# RENESAS TECHNICAL UPDATE

Product Category	MPU/MCU		Document No.	TN-SH7-A794A/E	Rev.	1.00
Title	Correction of Errors in SH7214 Group, SH7216 Group User's Manual (Hardware)		Information Category	Technical Notification		
Applicable Product	SH7214 Group SH7216 Group	Lot No.	Reference Document	SH7214 Group, SH7216 Group User's Manual: Hardware (REJ09B0543-0200)		
		All lots

Table 33.21 and figure 33.66 in section 33.3.17 "H-UDI Related Pin Timing" of section 33 "Electrical Characteristics" on p. 1808 and p. 1809, respectively, are corrected as follows.

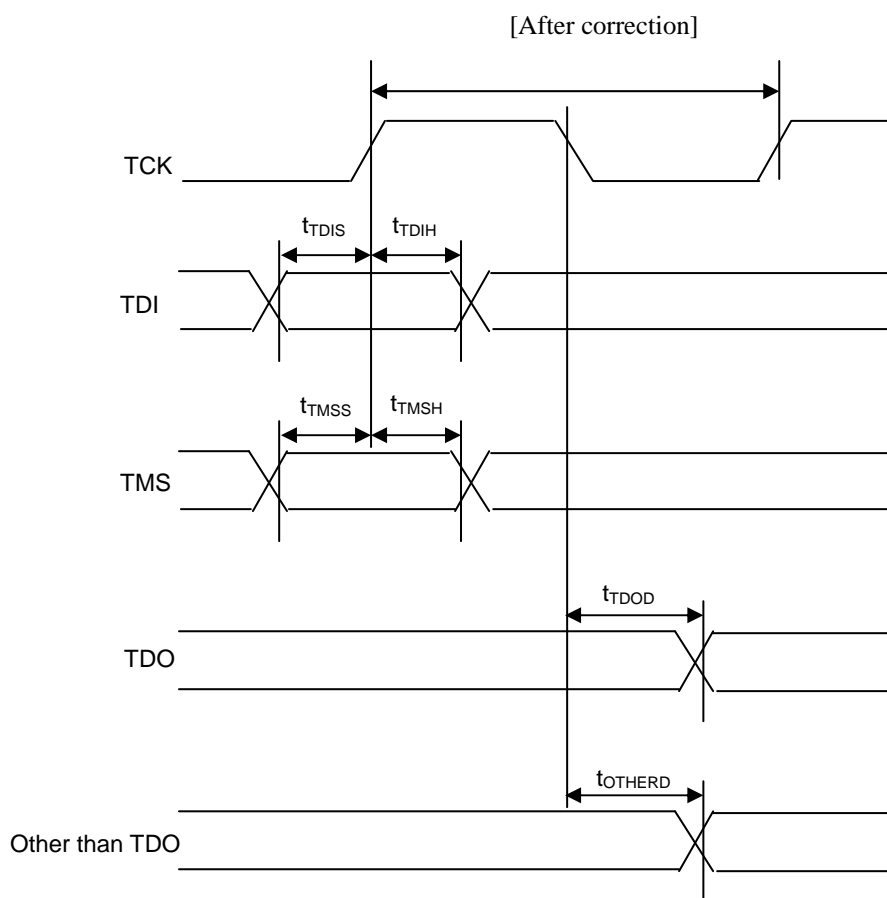
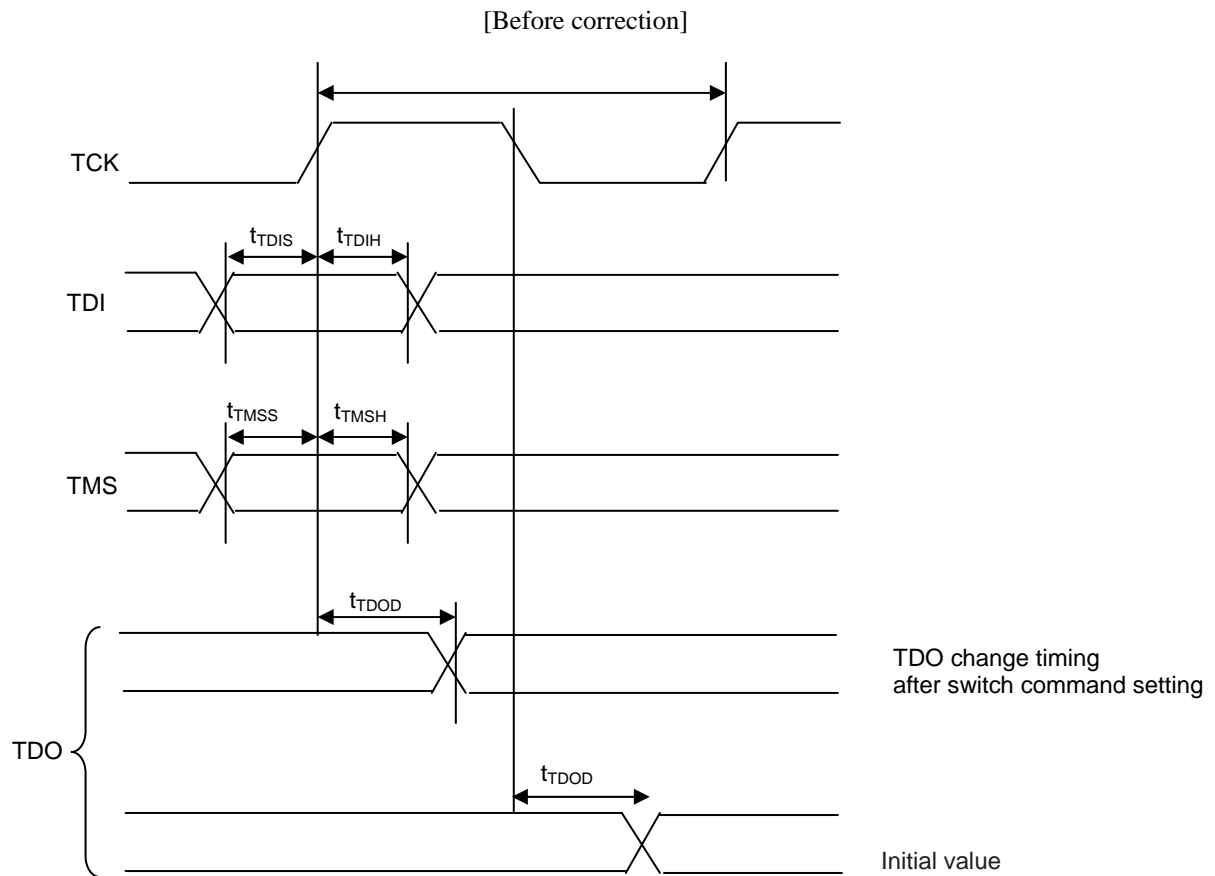
[Before correction]

Item	Symbol	Min.	Max.	Unit	Figure
TCK cycle time	$t_{TCKcyc}$	50*	—	ns	Figure 33.65
TCK high pulse width	$t_{TCKH}$	0.4	0.6	$t_{TCKcyc}$	
TCK low pulse width	$t_{TCKL}$	0.4	0.6	$t_{TCKcyc}$	
TDI setup time	$t_{TDIS}$	15	—	ns	Figure 33.66
TDI hold time	$t_{TDIH}$	15	—	ns	
TMS setup time	$t_{TMSS}$	15	—	ns	
TMS hold time	$t_{TMSH}$	15	—	ns	
TDO delay time	$t_{TDOD}$	—	30	ns

[After correction]

Item	Symbol	Min.	Max.	Unit	Figure
TCK cycle time	$t_{TCKcyc}$	$40^{*1}$	—	ns	Figure 33.65
		$160^{*2}$	—	ns	
TCK high pulse width	$t_{TCKH}$	0.4	0.6	$t_{TCKcyc}$	
TCK low pulse width	$t_{TCKL}$	0.4	0.6	$t_{TCKcyc}$	
TDI setup time	$t_{TDIS}$	15	—	ns	Figure 33.66
TDI hold time	$t_{TDIH}$	15	—	ns	
TMS setup time	$t_{TMSS}$	15	—	ns	
TMS hold time	$t_{TMSH}$	15	—	ns	
TDO delay time	$t_{TDOD}$	—	$30^{*1}$	ns	
		—	$80^{*2}$	ns	
Output pins other than TDO	$t_{OTHERD}$	—	$80^{*2}$	ns

Notes: 1. This value must exceed the cycle time for the peripheral clock ( $P\phi$ ).

2. TCK cycle time when the boundary scan function is executed
